Project	CMHA Meadows RAD Renovations	Addendum Number	2
Project Number	18076.04	Date	09/12/2025
To	All Bidders		
<i>This addendum contains changes to the requirements of the bidding Documents, Project Manual and Construction Drawings which have been issued to date. Such changes are to be incorporated into the Construction Documents and shall apply to the work in the same meaning and force as if they had been included in the original documents. Wherever this Addendum modifies a portion of a paragraph of the Project Manual or a portion of any Drawing, the remainder of the paragraph or Drawing shall remain in force.</i>			
General	Clarifications: <i>Bid Form: See attached revised bid form showing line item for permit fee included.</i> <i>Do the gas lines in the laundry room need to be removed? Is the furnace the only gas fed item within the unit?</i> Response: Gas lines are stubbed into the laundry area for future use of a gas appliance. No work is to be done on the gas lines in the laundry room as a part of this renovation. <i>How should the curb be addressed where the sidewalk on the accessible route widens?</i> Response: See Civil drawings updates as a part of this Addendum. <i>Do y

13 PLAN COMMUNITY CENTER - GROSS AREA
1/16" = 1'-0"

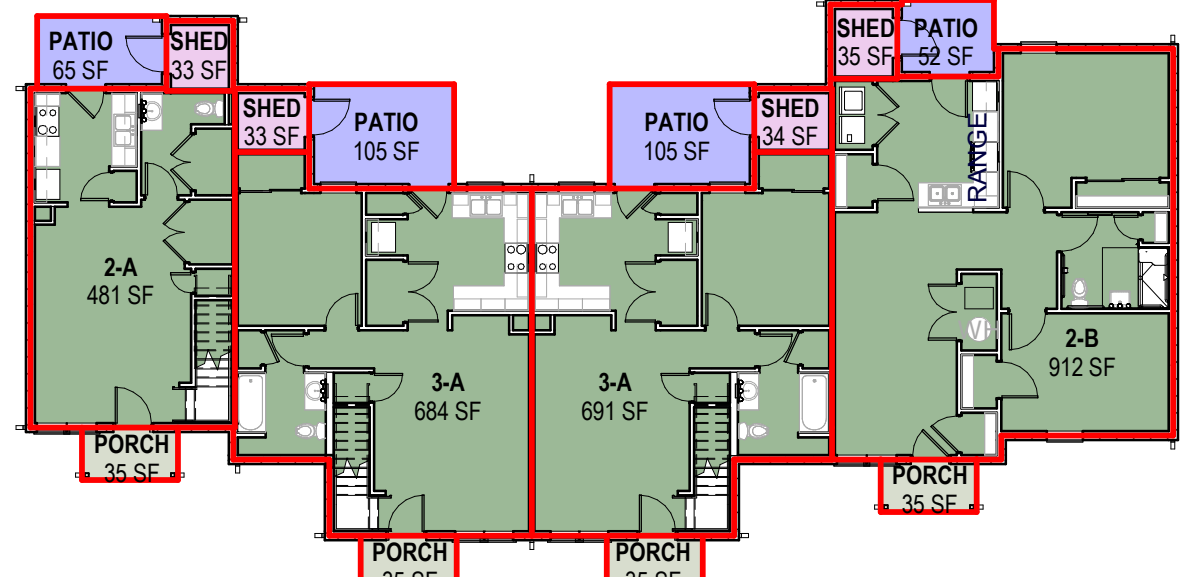
Specifications	None		
General	Sheet G006 – AREA PLANS – GROSS - REVISED Plan 13 and Area Schedule at Community Center per scope updates. Sheet G007 – AREA PLANS – NET - REVISED Plan 13 and Area Schedule at Community Center per scope updates.		
Civil	Sheet C101 – FINAL SITE COMPLIANCE PLAN - REVISED handicapped ramp and sign callouts. - ADDED hatch for full depth asphalt pavement replacement. - REVISED roof leader note. - ADDED note for additional 100sf of full depth asphalt replacement. - ADDED Coded Note 16. Sheet C102 – FINAL SITE COMPLIANCE PLAN - ADDED hatch for full depth asphalt pavement replacement. - REVISED roof leader note. - ADDED note for additional 100sf of full depth asphalt replacement. - ADDED Coded Note 16.

Sheet C301 – DETAILS

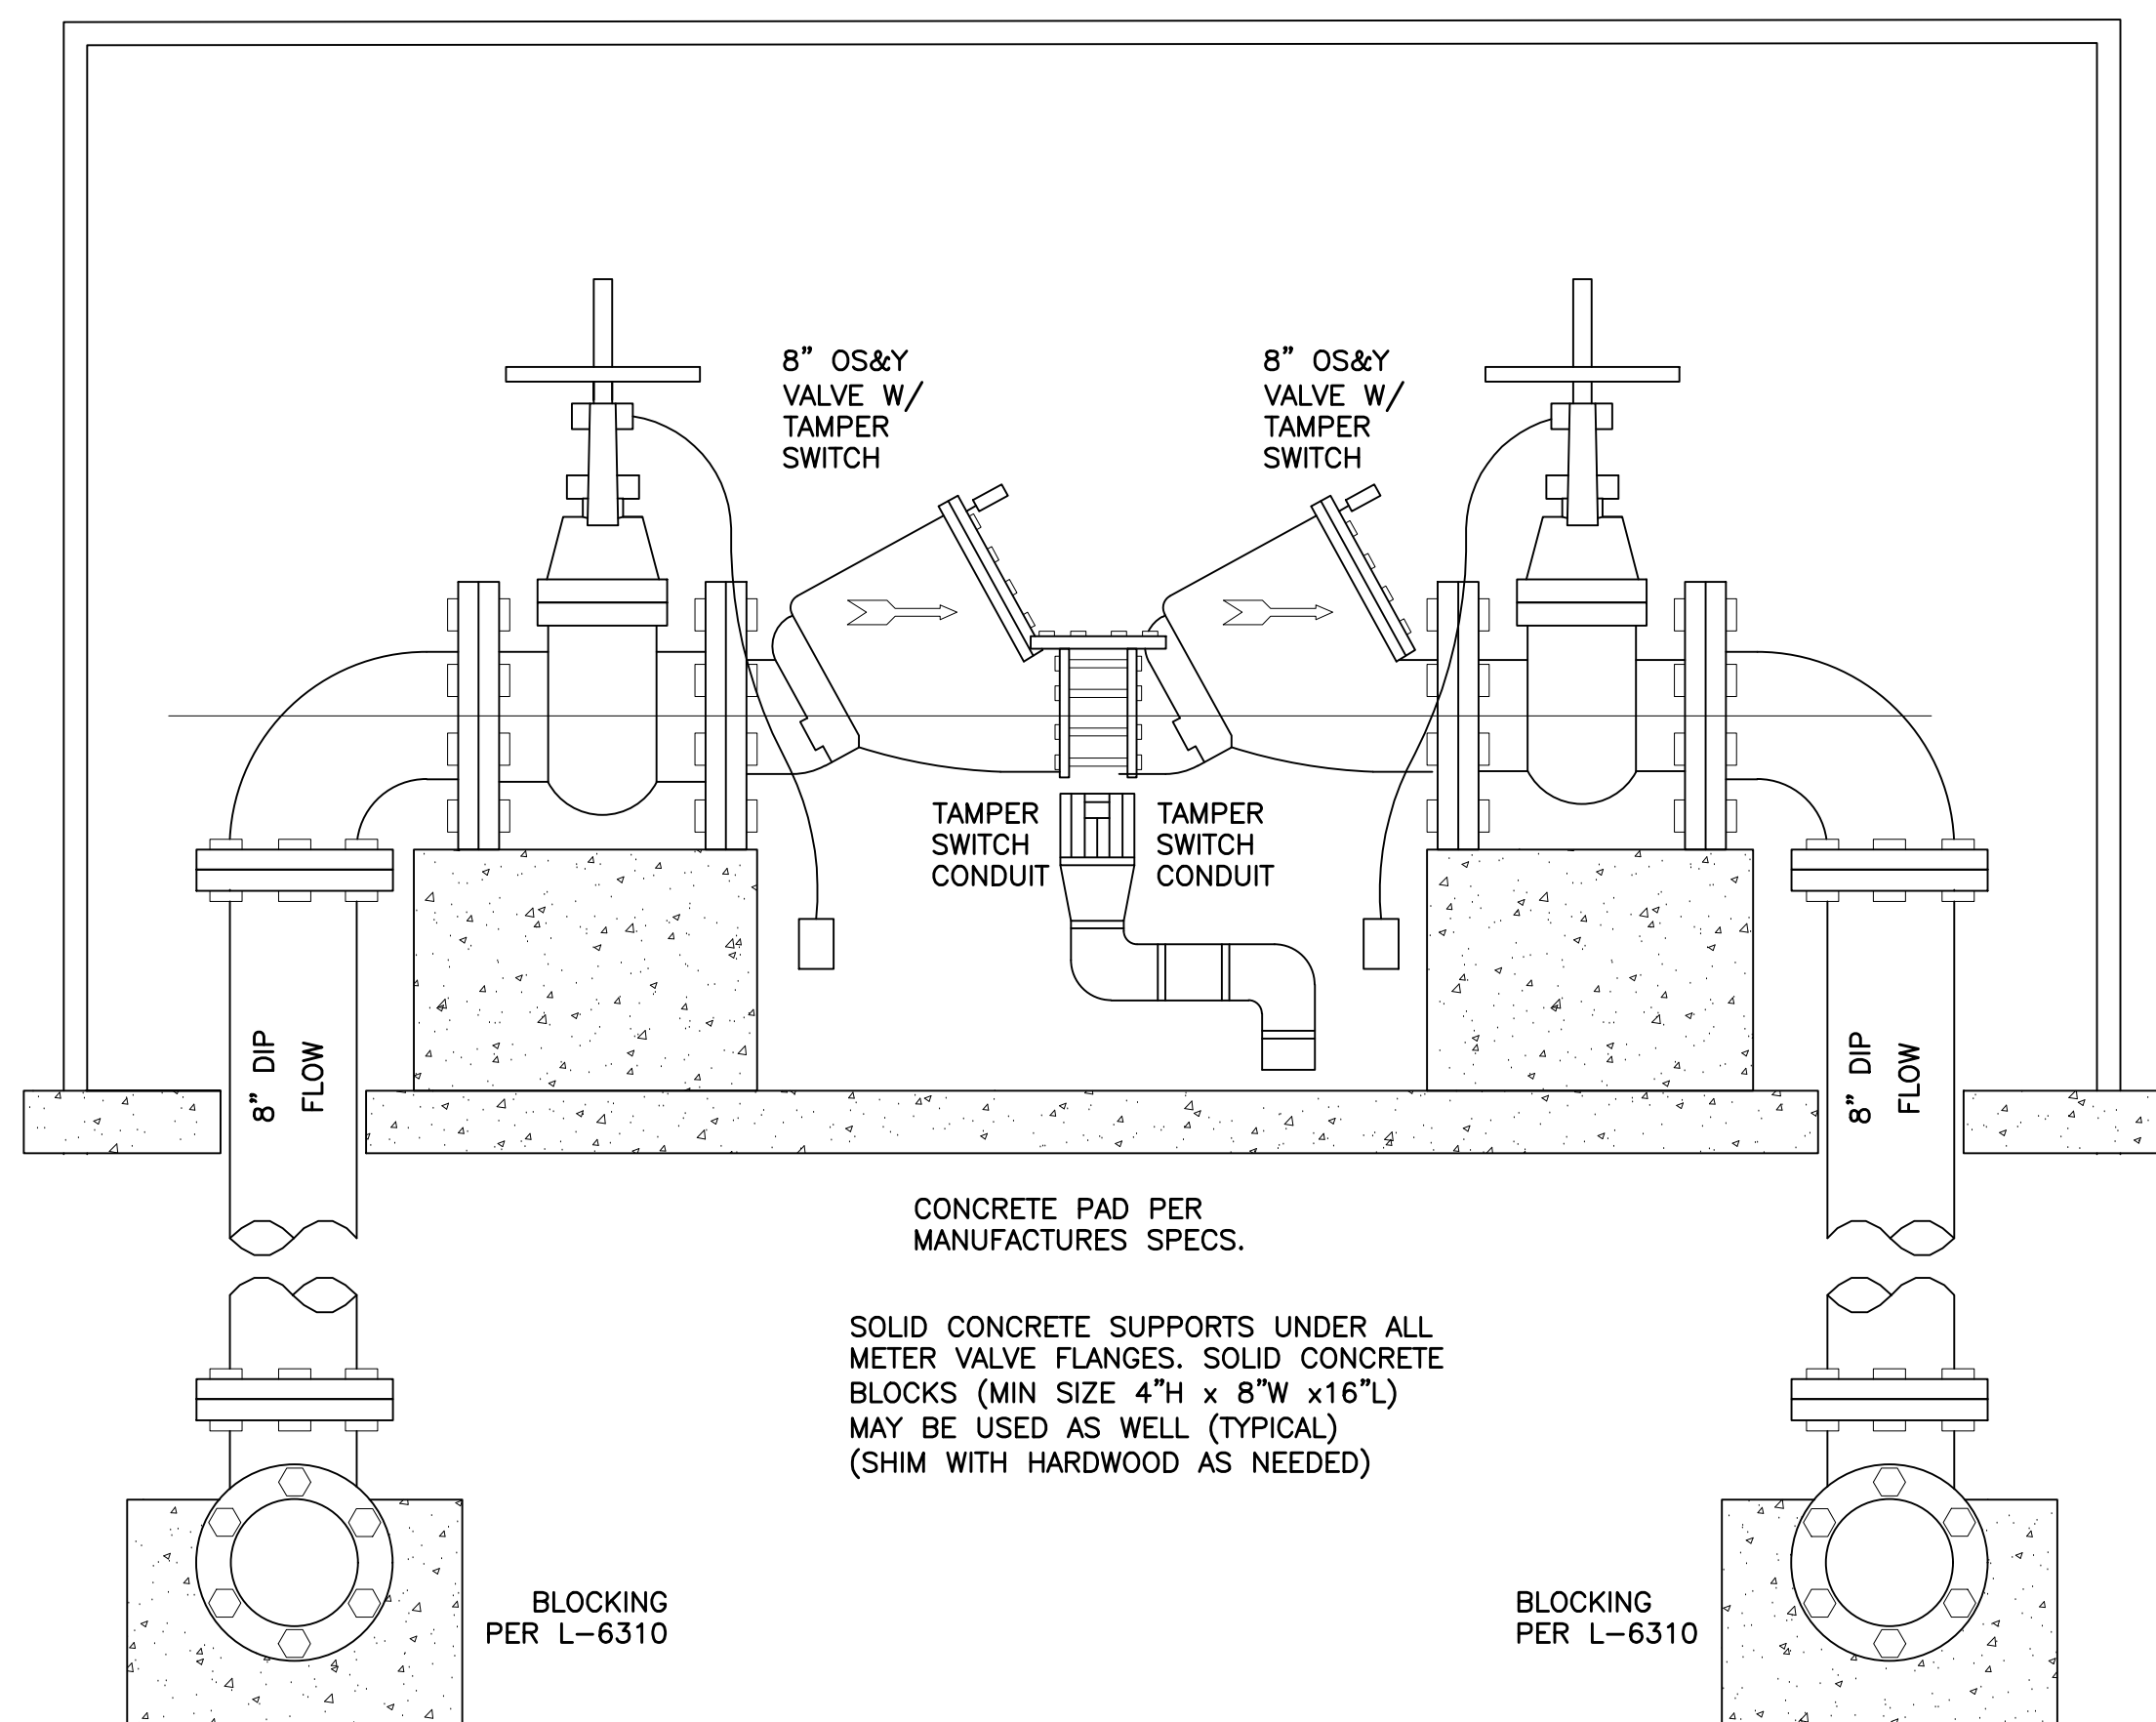
1. REVISED walk detail to include sawcut at curbline.
2. ADDED full depth pavement section.
